**CITY OF SEATTLE
ANALYSIS AND DECISION OF THE DIRECTOR
OF THE DEPARTMENT OF PLANNING AND DEVELOPMENT**

Application Number: 3009828
Applicant Name: Tom Fanning for R. D. Merrill Co.
Address of Proposal: 4301 Stone Way North

SUMMARY OF PROPOSED ACTION

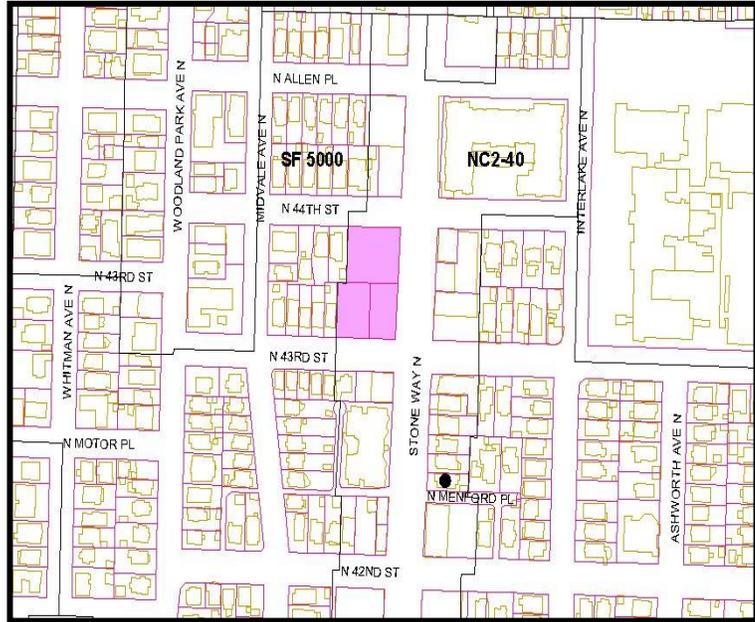
By the Recommendation meeting, Scheme #3 evolved to form a tripartite mass along Stone Way N. with the corners anchored by commercial spaces at grade and entries at chamfered corners that extend the full of the height of the proposed structure. A middle section, with its irregular mass slightly set back from the street, forms a narrow but linear plaza along Stone Way. Within this plaza, a residential entry and lobby sequence and another commercial storefront form the ground floor. Brick masonry units delineate the ground floor commercial spaces. Above the first level, the middle section of the scheme is composed of a series of projecting bays and residential balconies set in from the primary plane of the wall. The two corner masses are differentiated from the mid-section of the composition by the lack of bays and balconies creating quieter facades in contrast to the visual staccato of the middle section. Color choices for the fiber cement panels also set the corner masses apart from building’s middle realm.

The panels wrap around the corners to the north and south elevations for two bays. Lap siding and inset balconies primarily define the residential character of the units facing N. 43rd and N. 44th Streets.
